6002 Cottage Grove Road

Planned Unit Development: Specific Implementation Plan Grandview Commons Grocery Store

UDC Final Approval Request

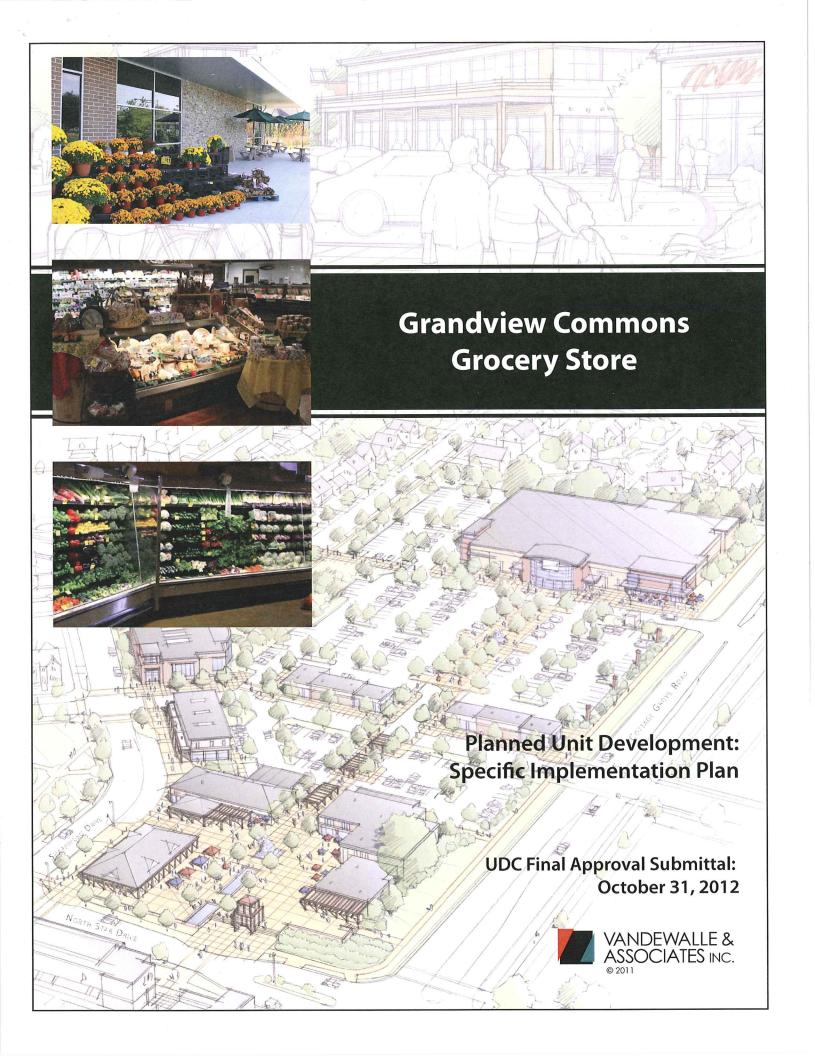
2.) Mechanical systems noise/visual mitigation

The mechanical systems have been screened with roof top noise/visual screens or enclosed within the refuse/storage area. These units generate the following decibel ratings HVAC (Condensers 60-83 dB(A), RTU's (55-94 dB (A)), Compactor (59 dB (A), 31 second cycle). The combination of screening and distance to adjoining homes effectively reduce the noise impact to comparable to the existing noise from the Interstate and Cottage Grove Road.

These systems are further mitigated aesthetically through the incorporation of the integrated visual screening and landscape screening (landscape layering and fence combinations) resulting in elimination of any direct sightlines to the units from all adjoining properties.
